**COMMUNITY AND ECONOMIC DEVELOPMENT DEPARTMENT  
PLANNING DIVISION**

**APPEAL OF DECISION OF PLANNING AND ECONOMIC DEVELOPMENT COMMISSION**

APPLICATION NUMBER APPEALED TTM 22-002, UPA 22-001, DR 22-001

APPELLANT'S NAME MONACHE CONDOMINIUM OWNERS ASSOCIATION, INC.

RENDERING - CANYON BLVD NORTH

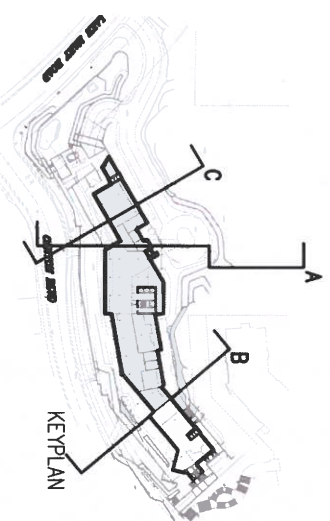
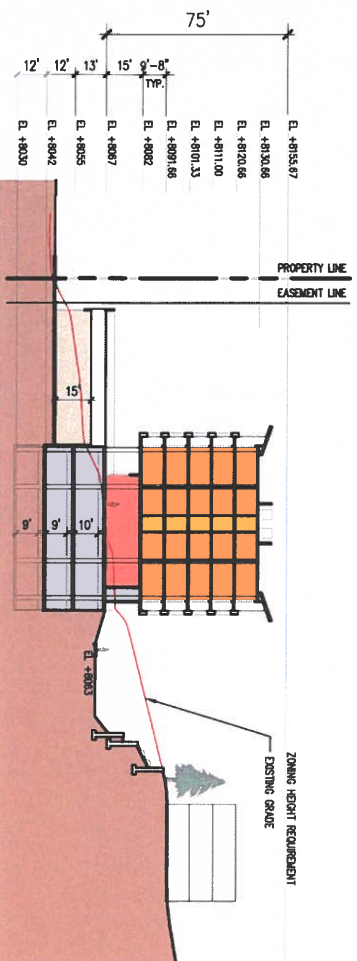
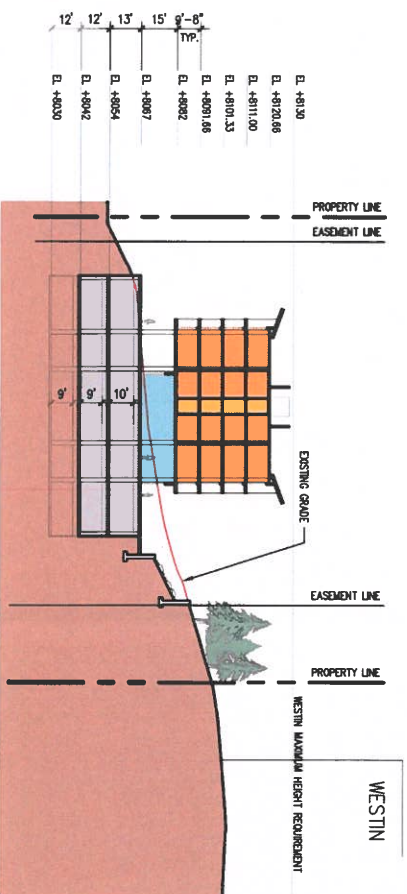
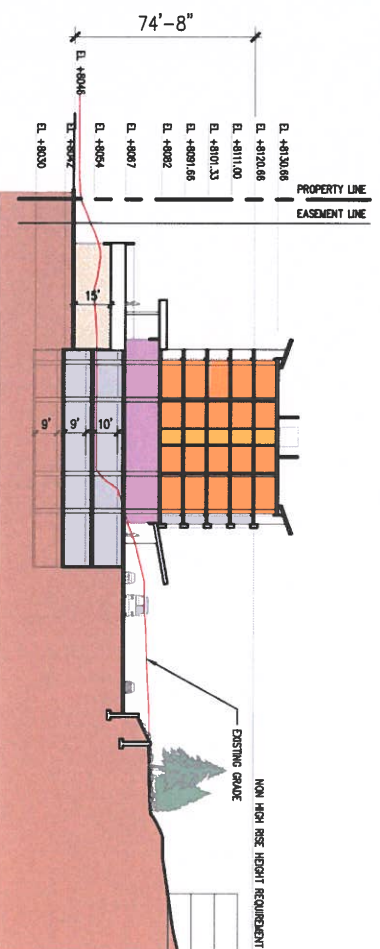
In short, further work should be done on the roof design to make it more compatible with the NVSP, the General Plan, the design guidelines and the immediate neighborhood.

Following are additional guidelines for roof design and mechanical equipment which argue for a revised roof design and concealed mechanical equipment.
